## O'REILLY AUTO PARTS DRAINAGE & PAVEMENT IMPROVEMENTS JSP21-35

**PLAN REVIEW CENTER REPORT**  
**Planning Review**  
**O'REILLY AUTO PARTS DRAINAGE & PAVEMENT IMPROVEMENTS**  
 JSP 21-35

**Review Date:** March 2, 2022  
**Review Type:** Preliminary Site Plan Review  
**Project Name:** JSP21-35 O'Reilly's Paving & Drainage Improvements  
**Location:** 43131 Grand River Ave; Parcels 22-23-102-026/027  
**Plan Date:** January 25, 2022  
**Prepared by:** Christian Carroll, Planner  
**E-mail:** [ccarroll@cityofnovi.org](mailto:ccarroll@cityofnovi.org) **Phone:** (248) 735-5607

**43181 GRAND RIVER**  
 DRAINAGE AND PAVEMENT IMPROVEMENTS  
 CITY OF INDIAN OAKLAND COUNTY, MICHIGAN  
 EXISTING CONDITIONS & REMOVALS

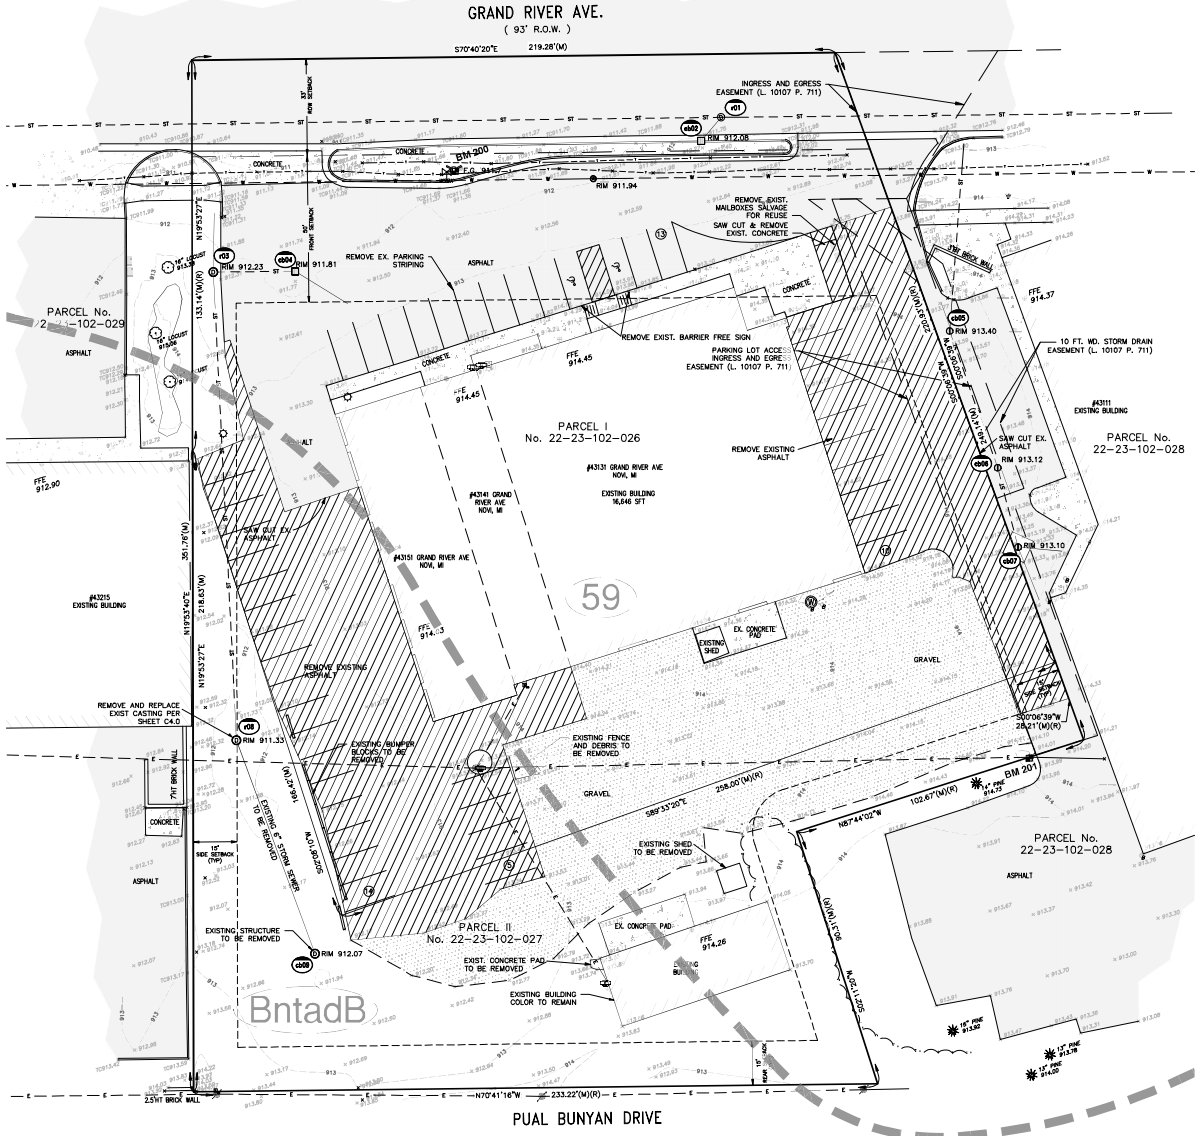
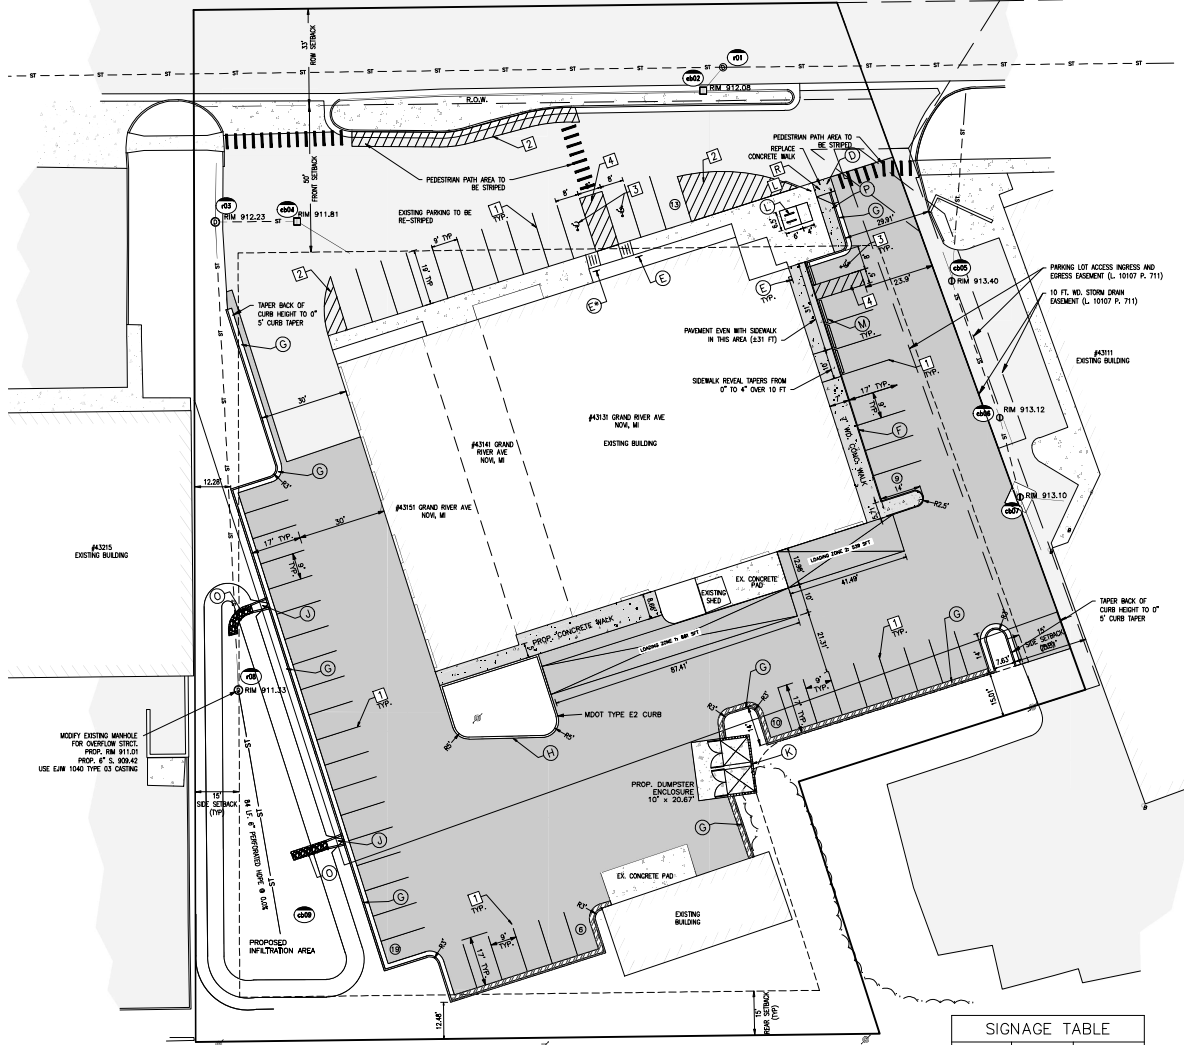
1. Provide a minimum of two ties to established section or quarter section corners.
2. At least one referenced benchmark must be a City-established benchmark, which can be found on the City's website at this location: <https://novi.maps.arcgis.com/apps/webappviewer/index.html?id=5ce841f86197461c9f146e1330330bcf>  
City benchmark #2314 is elevation 914.09 and is the southeast flange bolt of the same fire hydrant on Grand River that was used by Desine's benchmark #200 (top of steamer valve).

1. *Provide a minimum of two ties to established section or quarter section corners.*  
Ties are shown on sheet C2.0
2. *At least one referenced benchmark must be a City-established benchmark.*  
City-established benchmark #2314 shown on sheet C2.0.

# SITE IMPROVEMENTS PLAN

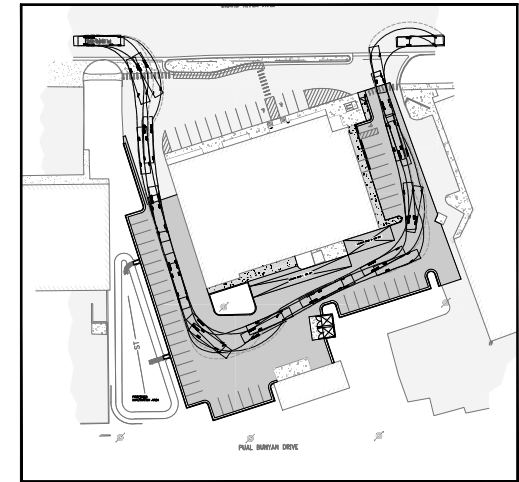
6. Parking Space Dimensions and Maneuvering Lanes (Sec. 5.3.2): The proposed parking spaces are 9 feet by 17 feet with 4 inch curbing. In addition, most access aisles meet the minimum requirement of 24 feet. **However, please revise the rear access aisle from ~21 feet to 24 feet to meet the minimum requirements. This could be done by adjusting the size and/or location of the loading area.**

Loading area space was revised on sheet C3.0 to provide a 24.5 feet access aisle.

**43131 GRAND RIVER**  
 DRAINAGE AND PAVEMENT IMPROVEMENTS  
 CITY OF NOVI, OKLAHOMA COUNTY, MICHIGAN  
 GRADING & UTILITY PLAN

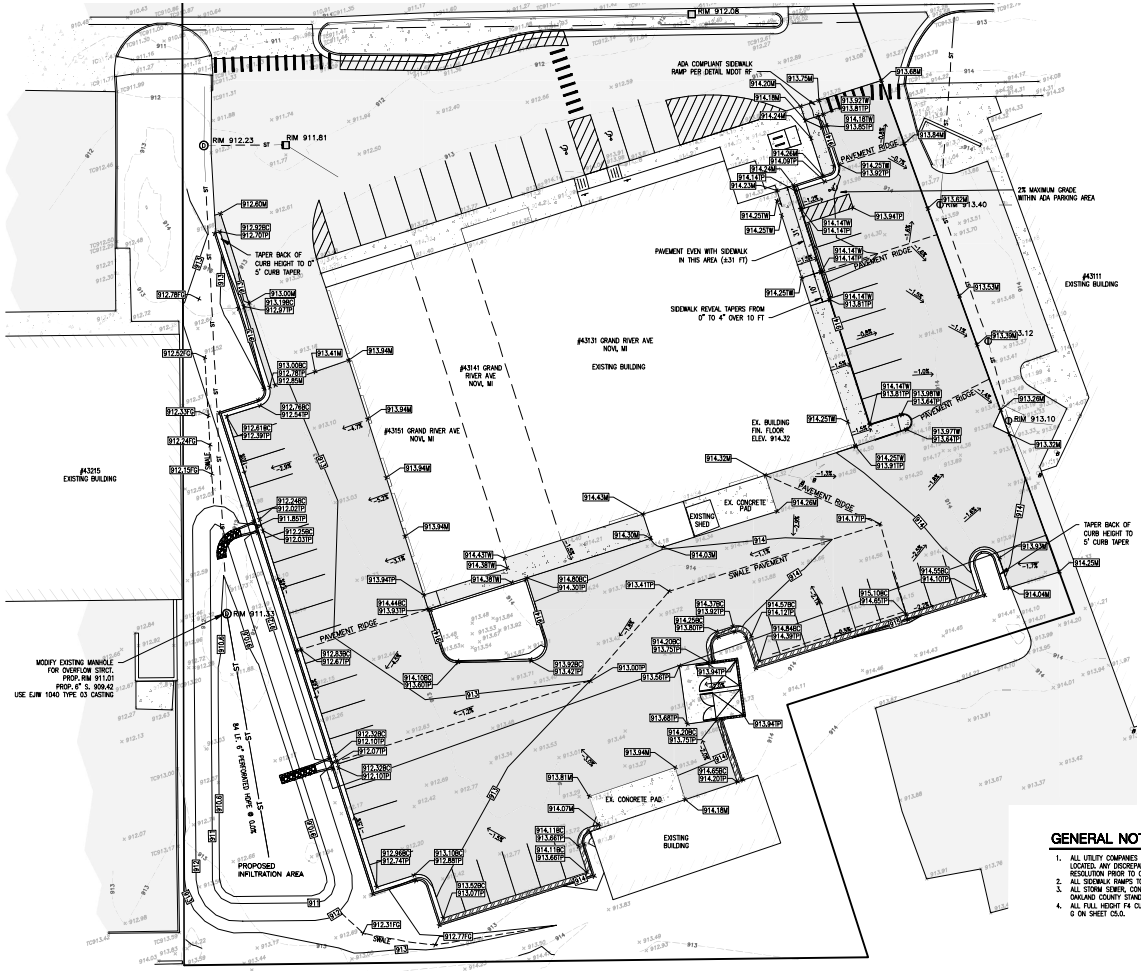
8. The Storm Water Management Plan (SWMP) for this development shall be designed in accordance with the Storm Water Ordinance and Chapter 5 of the Engineering Design Manual.
9. As part of the Storm Drainage Facility Maintenance Easement Agreement, provide an access easement for maintenance over the storm water detention system and the pretreatment structure. Also, include an access easement to the detention area from the public road right-of-way.
10. The planting soil media shall consist of the following mixture: 50% topsoil/50% sand or 20% topsoil/60% sand/20% compost.
11. Cleanouts shall be provided at the upstream end of the proposed underdrain for periodic maintenance.
